8/20/18 - sheets 4 & 5 added w/ proper finish on 2nd floor  
 9/20/18 - shelving corrected  
 11/5/18 - corrected 6A - (20" LVL)  
 12/12/18 - Added tub Deck 1st Floor Master (Platform tub)  
 12/28/18 - 6A corrected to match Truss plan posted 1/19

**COVER SHEET**

**INVENTORY PROJECT**  
 LOT 8 - 13 TH AVE.  
 SAFETY HARBOR, FL.

**MODEL 2844**

FIRST FLOOR

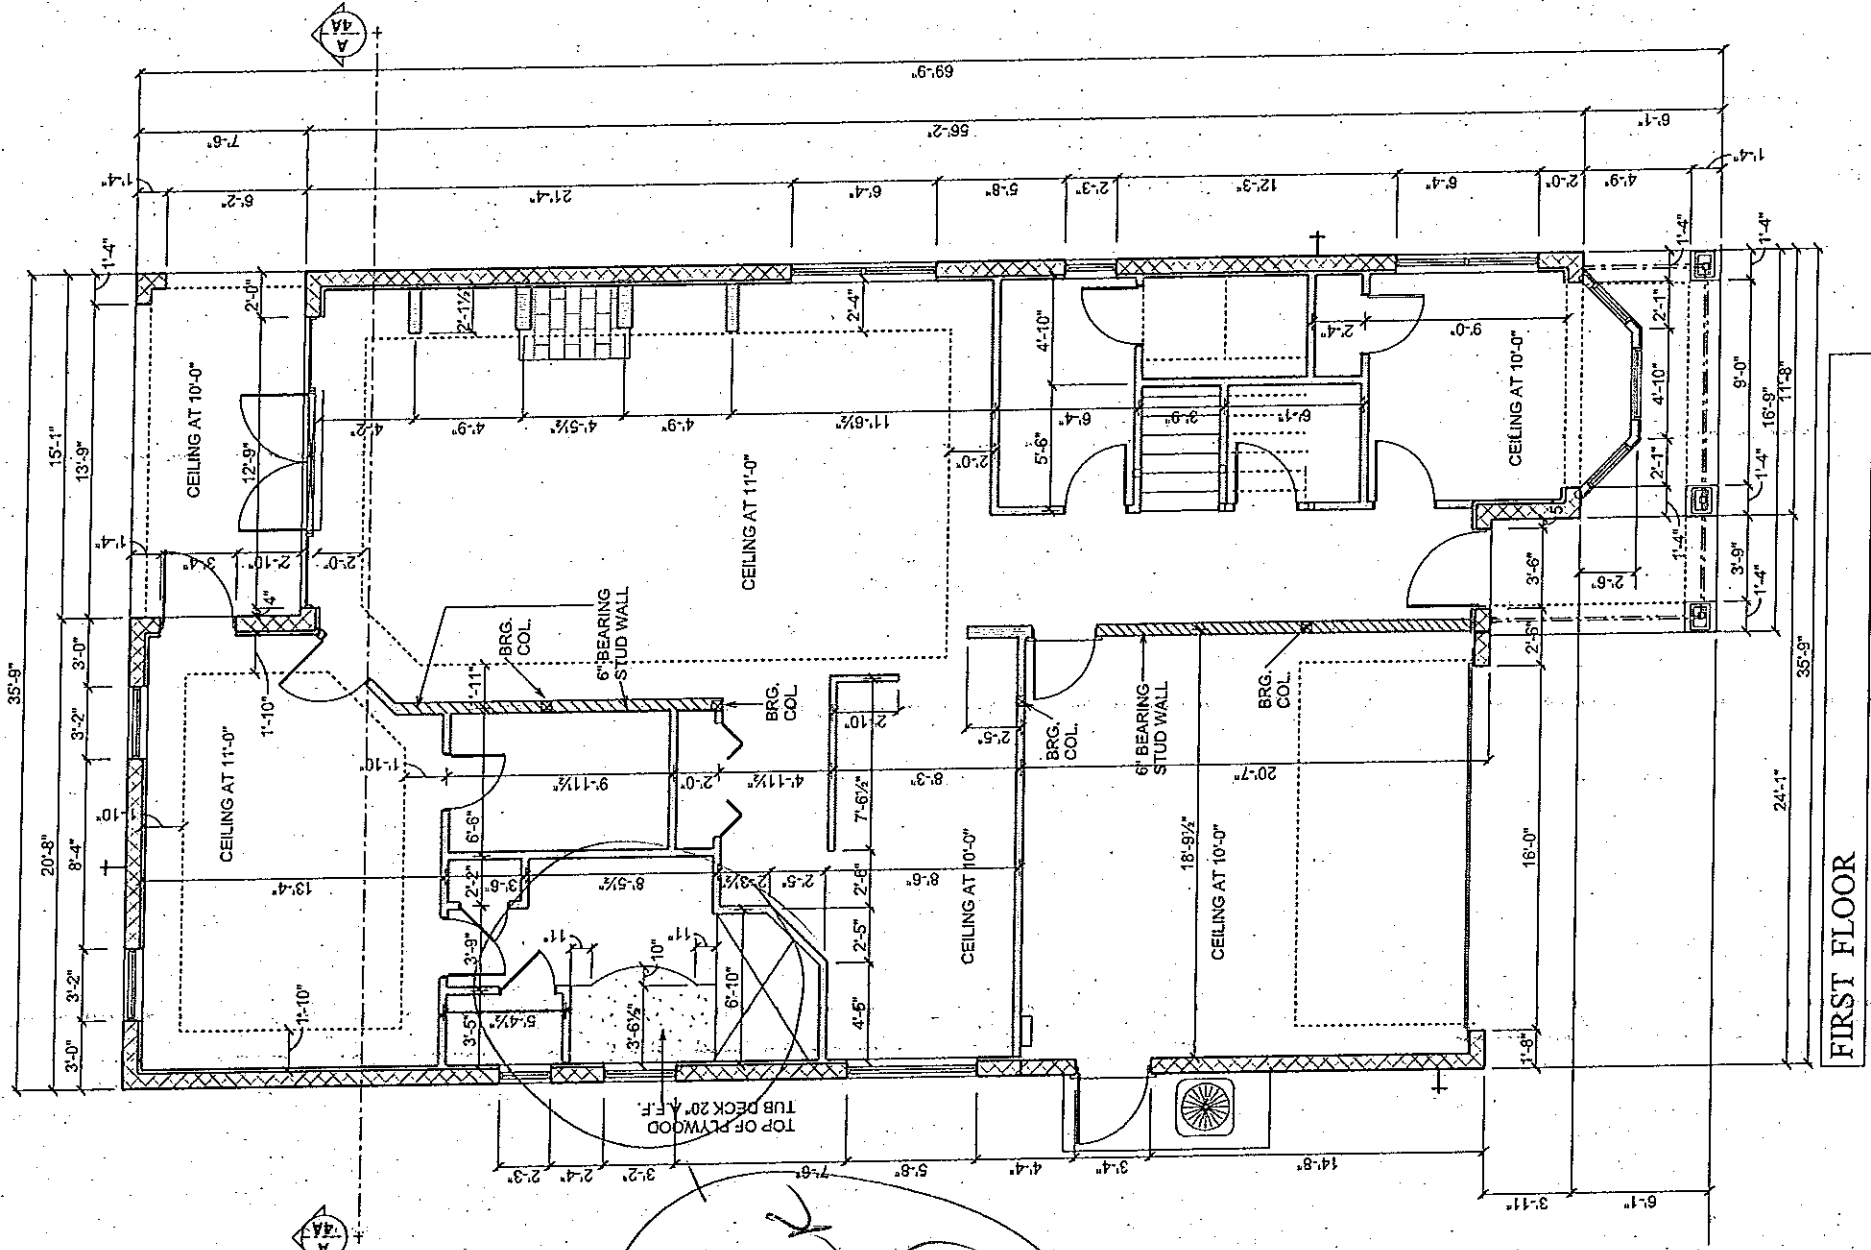
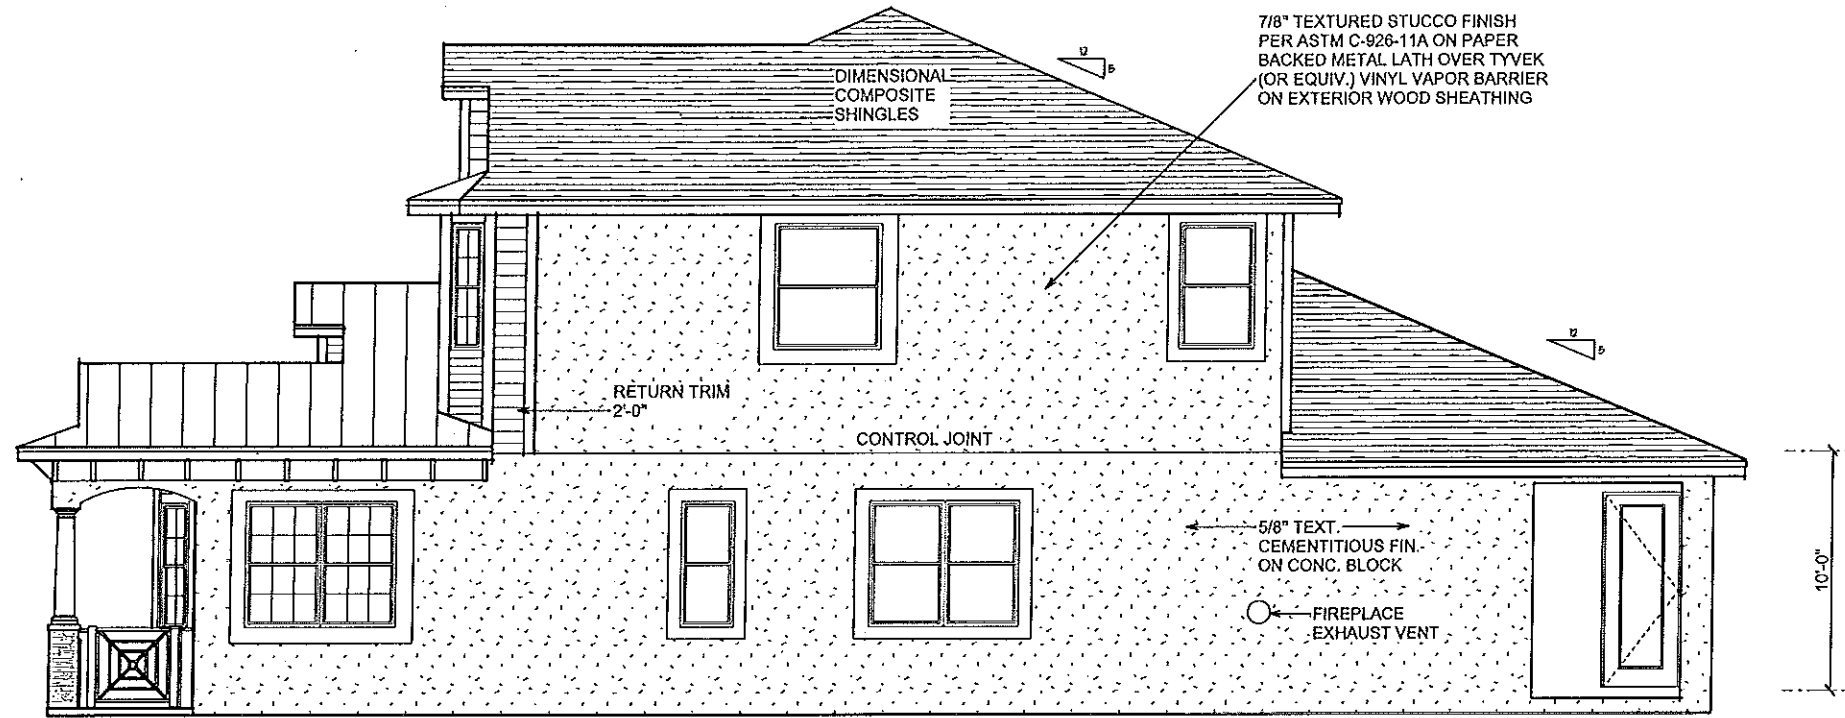
*Handwritten note:* Add Trans Deck from Porch

*Handwritten note:* Added Tub Deck  
3A
